St Leonards and Crows Nest - Draft Planning Package Submission

My submission is regarding the Draft 2036 Plan – in particular “Figure 25: Floor space ratio (FSR)” on page 51 of the document.

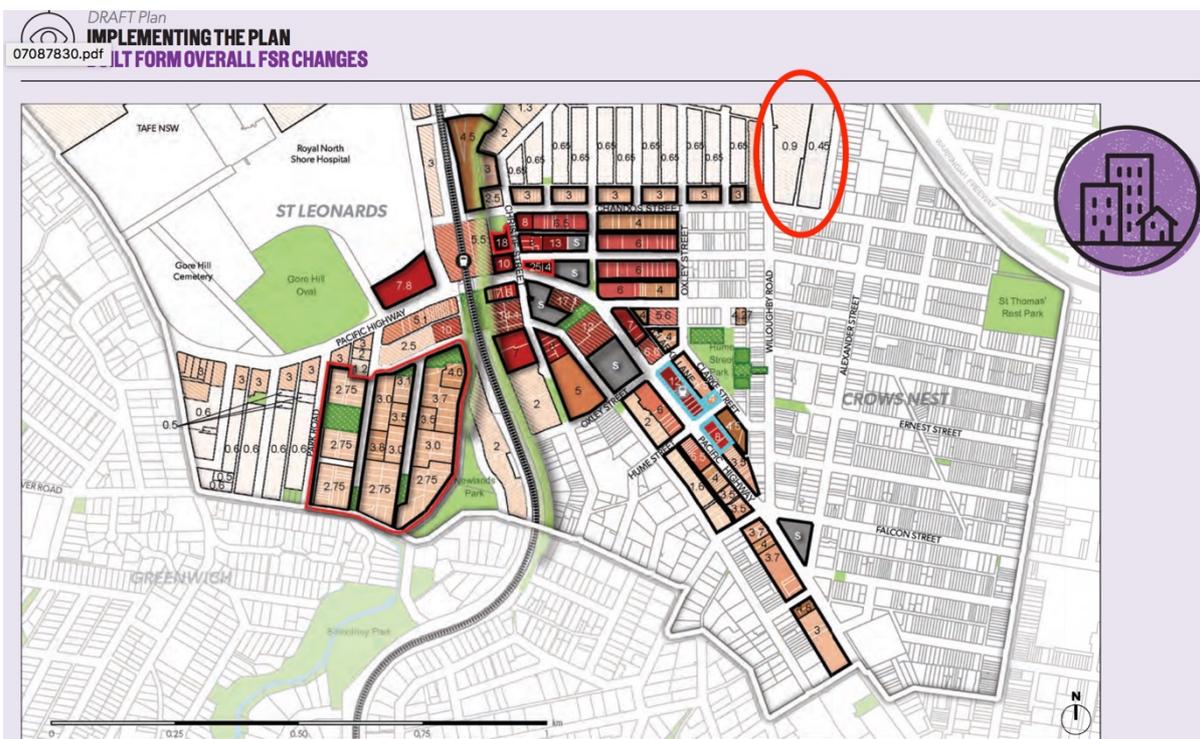
My concern with figure 25 is that it not only shows proposed FSR changes, but also includes some FSRs for areas that are not changing – which I believe is misleading.

I live in the area I have circled on figure 25 below:

The circled section of the map shows FSRs of 0.9 and 0.45.

The vast majority of the map (such as areas to the right of Willoughby Rd) do not show any FSR on the map – which clearly indicates there is no FSR change recommended.

However, the area where I live does include an FSR - even though it is the current FSR and no changes are recommended.

It is highly likely that in years to come a wide variety of different people such as council will use the ‘Draft 2036 Plan’ for reference and they could easily misunderstand that your intention is to specify an exact FSR for my area – when in fact my understanding is there are no recommended changes for my area.

Having large sections of the map with no FSR to indicate no changes and other sections (like my area) specifically showing an FSR could be very misleading.

I hope that you will consider my submission to make simple changes to figure 25 to more clearly show only FSR *changes* as the tile suggests.
